TECHNICAL MEMORANDUM

To: Ray Cody and Karen Simpson, United States Environmental Protection Agency, Region 1
From: Matt Lundsted and Nick Cristofori, CEI and Bruce Jacobs and Ken Hickey, WaterVision
Subject: **Task 1 Summary Memo: A description of recently completed data collection, conceptual design, and associated tasks.**
Date: February 17, 2015

EPA Green Infrastructure
Education and Outreach Project

Sheet
Figure
2

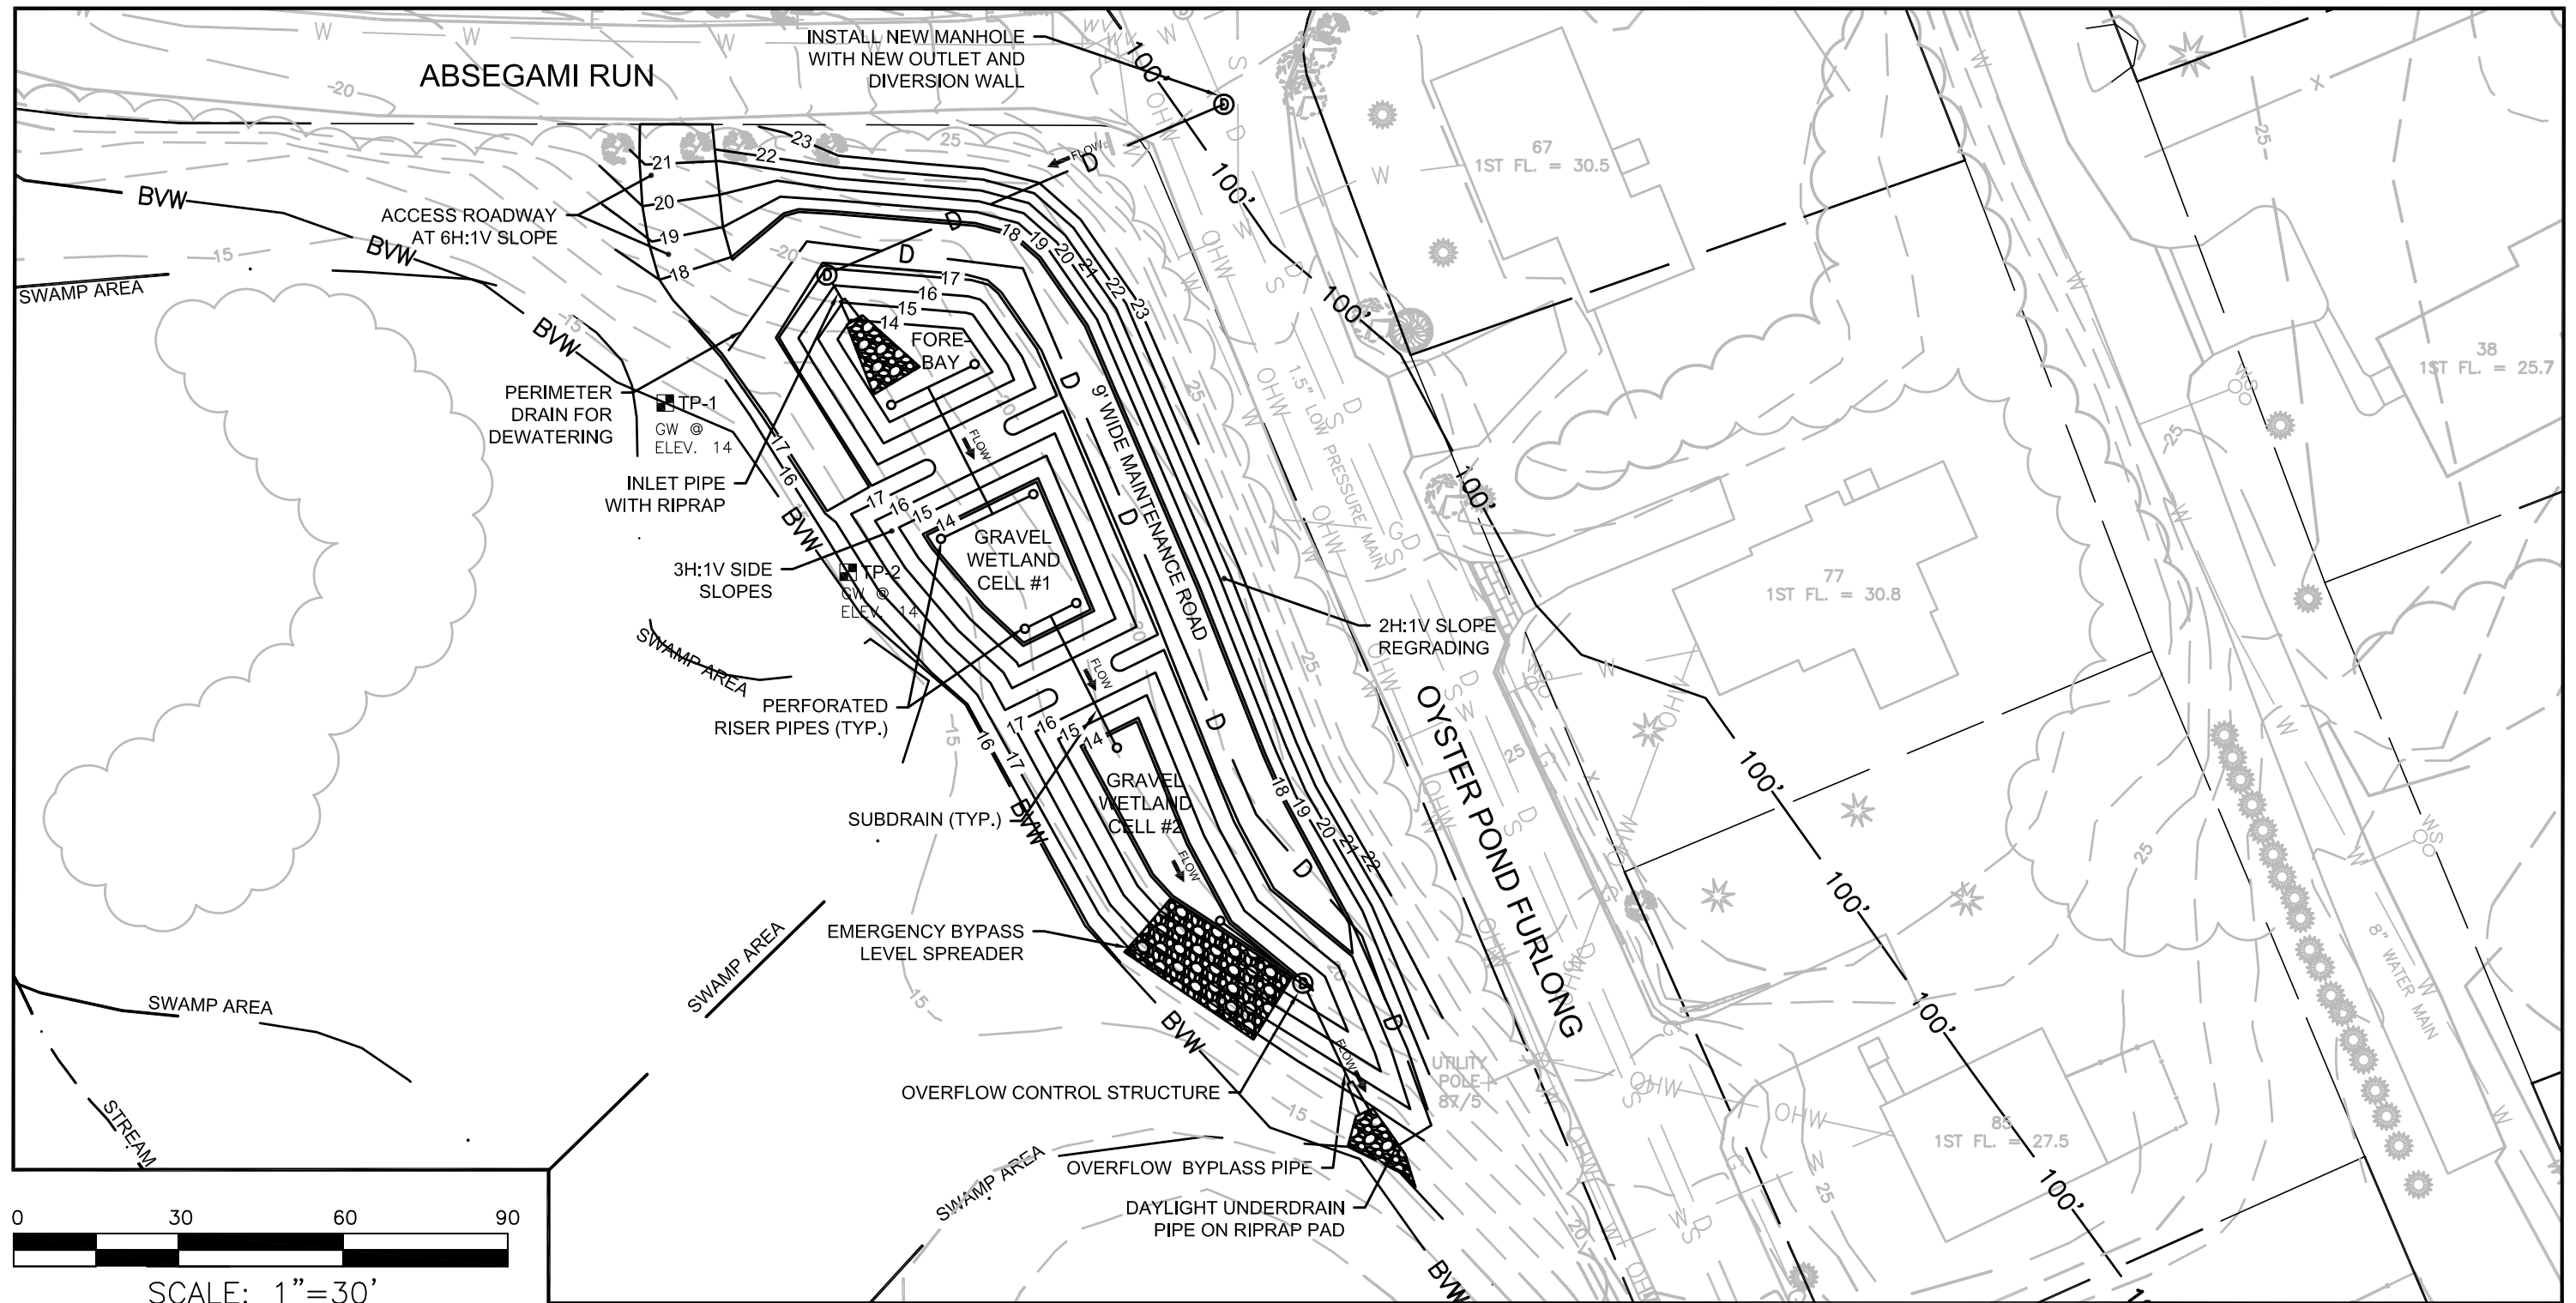
1. I read the document and reviewed the plans. I agree that according to the plan Figure 2 for Oyster Pond BMP in Chatham that a Corps permit would not be required according to these plans which depict no action [sic] physical filling in wetlands. The emergency bypass level spreader and overflow bypass pipe riprap is depicted adjacent to the wetland line. The plans do not indicate a datum which must be included and typically is required in NAVD 88 datum. [Edward Reiner]

4. Lastly, insofar as the overflow bypass pipe on the site plan (and the bottom of page 3 of the write up) which appears to discharge into the wetland area, would it not be advisable or preferred best engineering practice to avoid discharging into the wetland system? If additional funding could be obtained, is there a way to move this pipe and/or tie back into the MS4 system? It might at least be helpful to consider other options and cost them out. [Lynne Hamjian]

Acknowledged. Revised design plans and final Task 1 Summary Memo (T1SM) now indicate a horizontal datum of NAD83 and a vertical datum of NAVD88, consistent with survey information and MassGIS LiDAR used for design purposes.

The commenter is correct that the overflow bypass pipe should ideally not discharge directly into the wetland area in order to preserve existing hydrologic characteristics. The bulk of wetland areas are located directly west of the proposed BMP. As the wetland complex moves further south, it becomes channelized into a drainage ditch which drains through a culvert below two driveways associated with house numbers 98 and 100 on Oyster Pond Furlong. At this point, it no longer functions as a wetland, but instead as a drainage conveyance channel. This channel ultimately flows back into the drainage trunk line below Oyster Pond Furlong south of the southernmost driveway where it outlets into Oyster Pond approximately 500-feet further. Pending final design, it appears likely that the overflow pipe and erosion pad will be rotated such that it faces nearly due south, and thus discharges directly into the drainage channel portion rather than wetland areas. The final T1SM has been updated to clarify these connections.

**Figure
4**

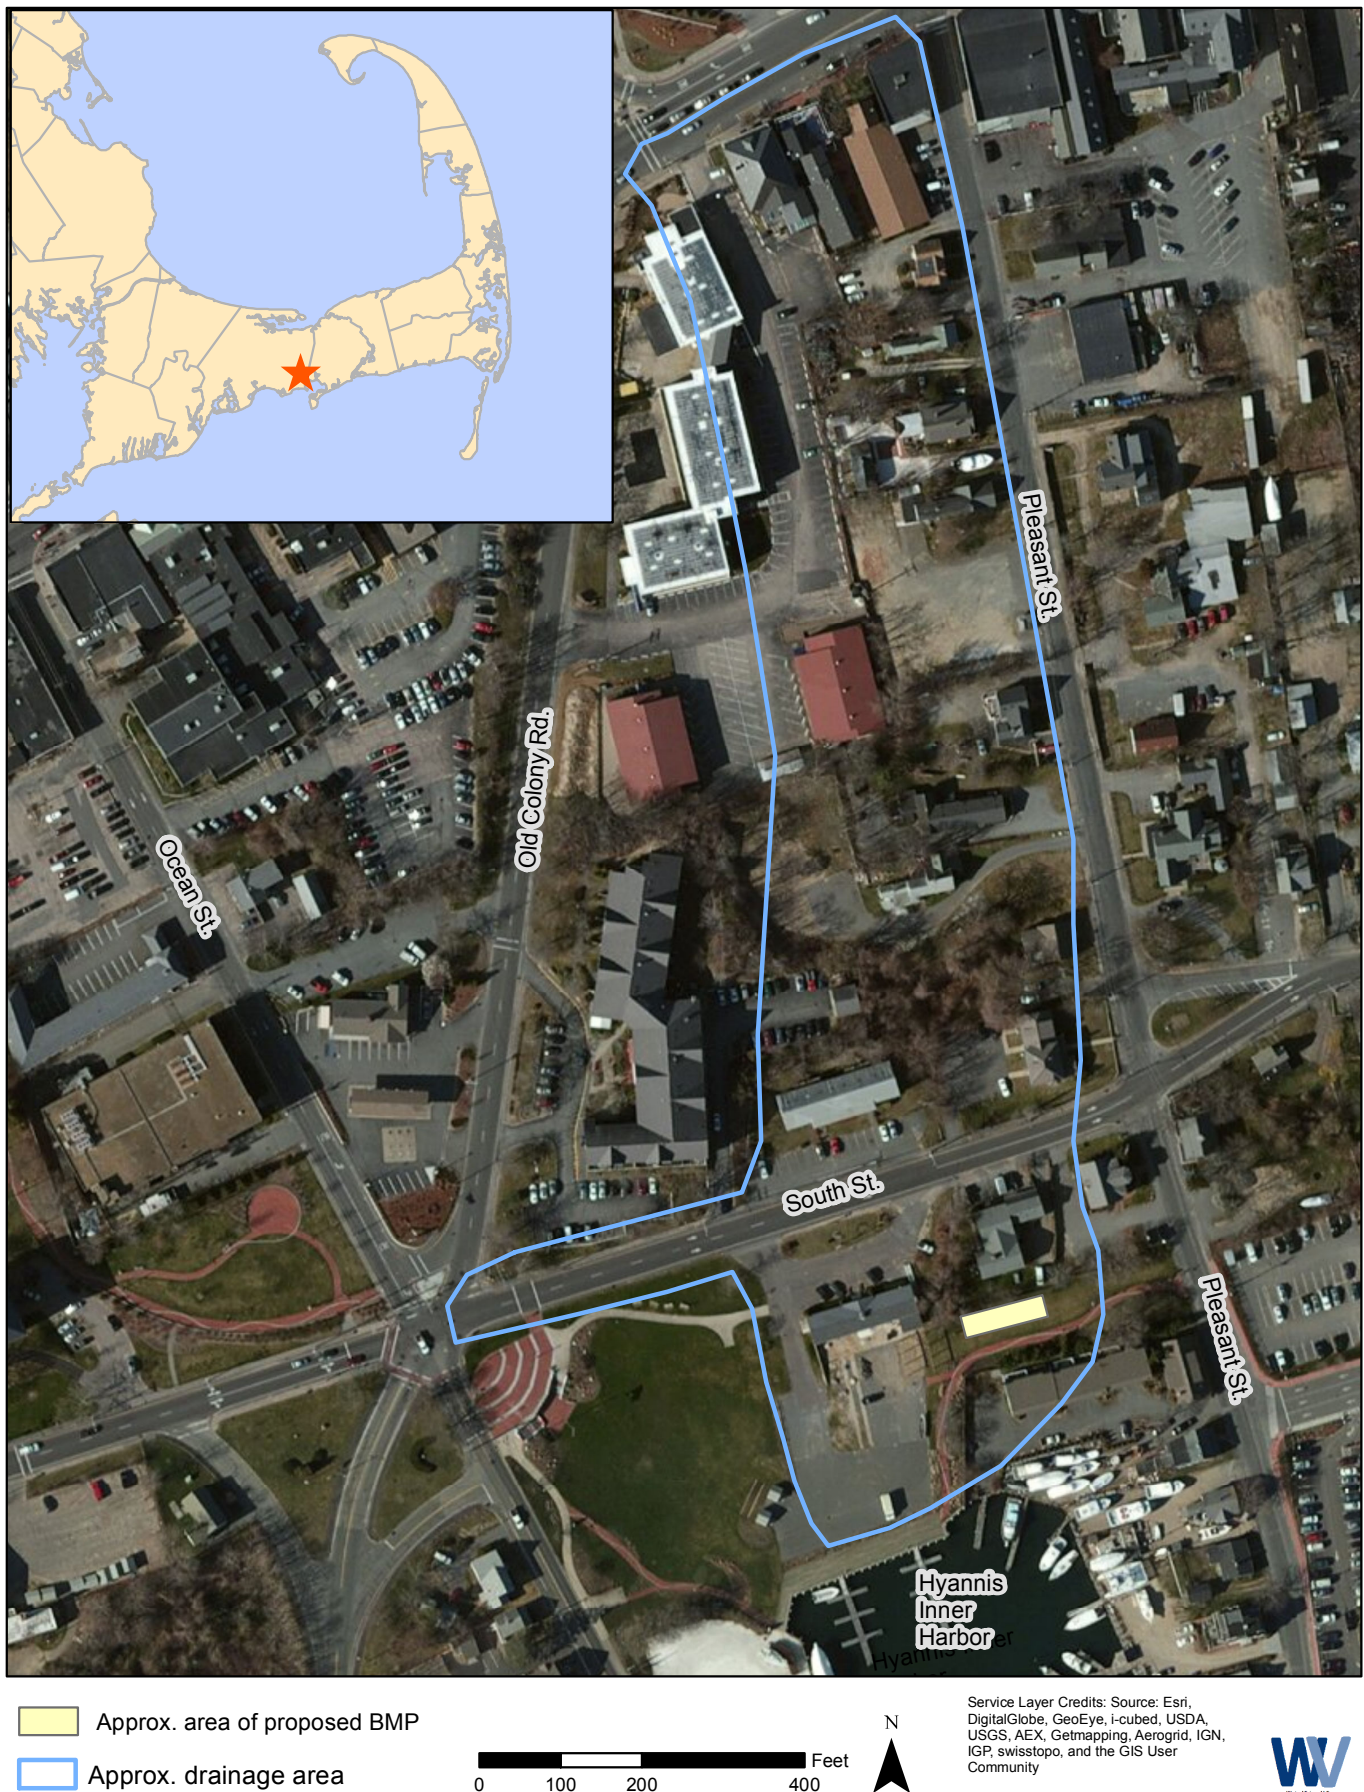
33. Design Figures. As we discussed, it would help to clarify / label the aerobic versus anaerobic zones of the treatment cells; otherwise, as we discussed, it almost appears as if the entire first of the two cells is an aerobic treatment cell and that the system only treats

Acknowledged. Revised design plans are attached to this response to clarify aerobic and anaerobic portions of each cell. Additionally, Figure 4 and Figure 7 contain cross sections for each BMP and outline a step-by-step guide to the stormwater treatment process and identifies all major design features.

Figure
6

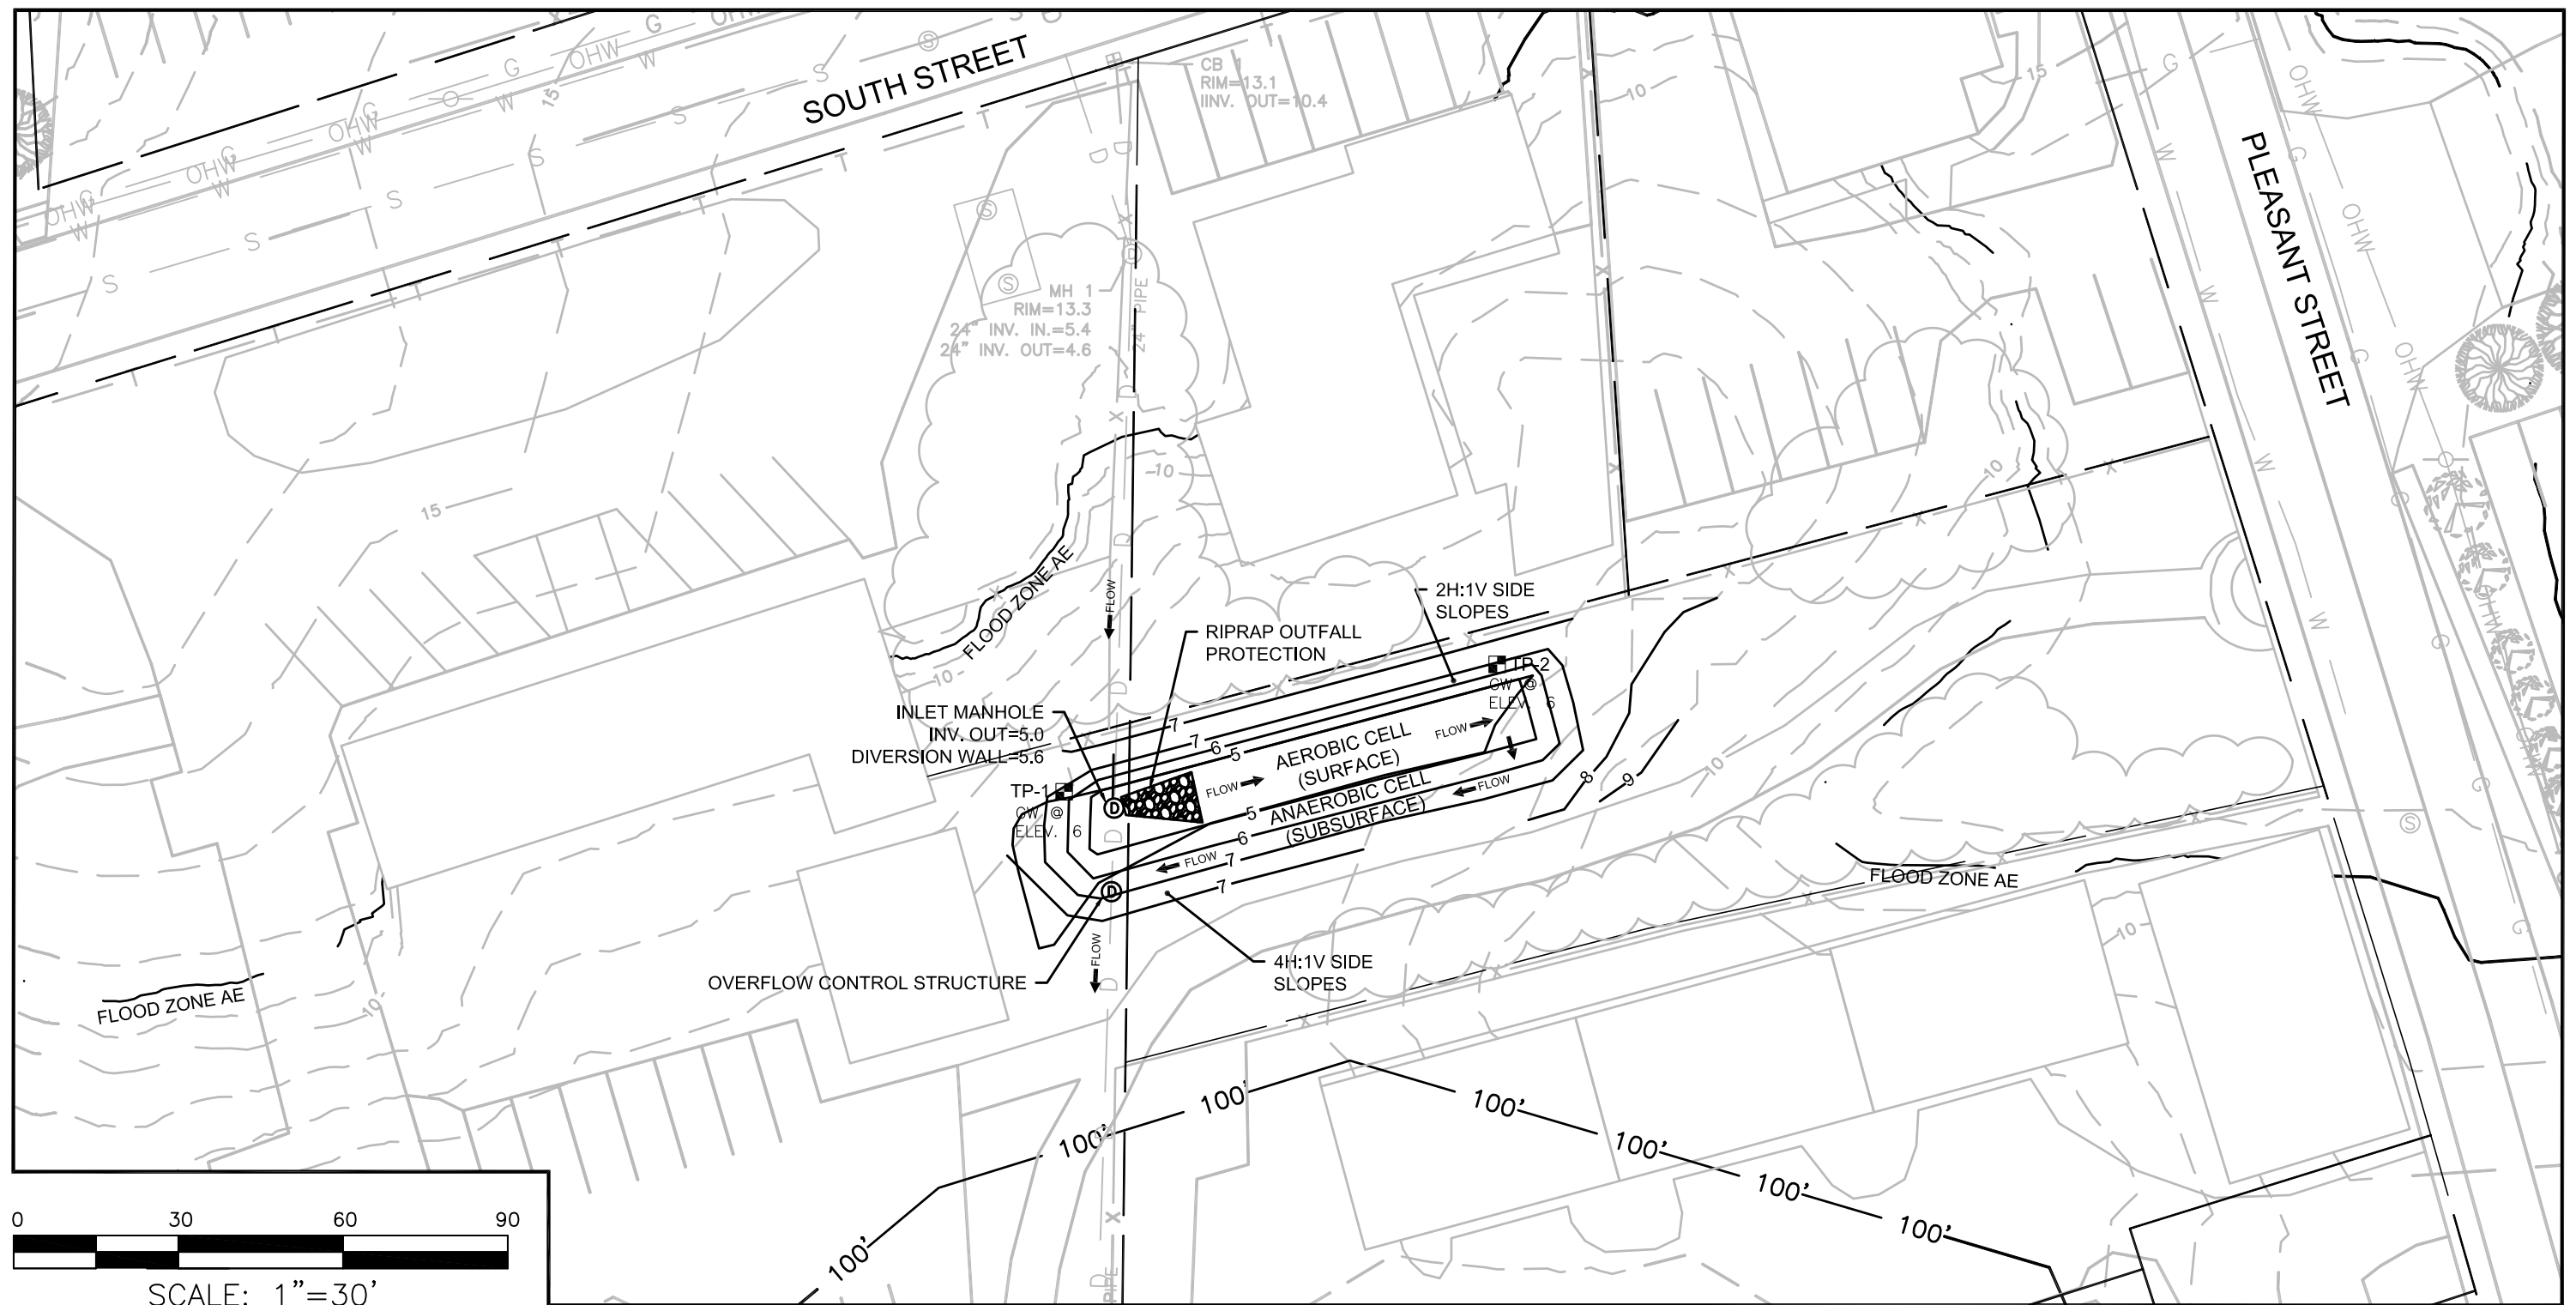
2. The plans for the Hyannis site depict and claim that no permitting will be needed since the location is not in wetlands and out of the buffer zone. I noticed, however, that the site itself may be in the 100-year flood plain and the aerobic cell (surface) will be excavated below 5 feet elevation (no datum reference provided). The plans should provide the datum reference (NAVD 88) and information on the 100-year floodplain. The potential impacts of sea level rise should also be considered as it relates to any backwater from the culvert drain at Hyannis Harbor. [Edward Reiner]

The Barnstable location is situated within a Flood Insurance Rate Map (FIRM) Special Flood Hazard Area (SFHA) area, classified as Zone AE with a Base Flood Elevation (BFE) of elevation 12.0 (NAVD88) based on FIRM Panel 0569J for Barnstable County. This zone is classified as areas subject to inundation by the 1-percent-annual-chance flood event, also known as the 100-year storm flood zone. Design plans have been updated to reflect this area.
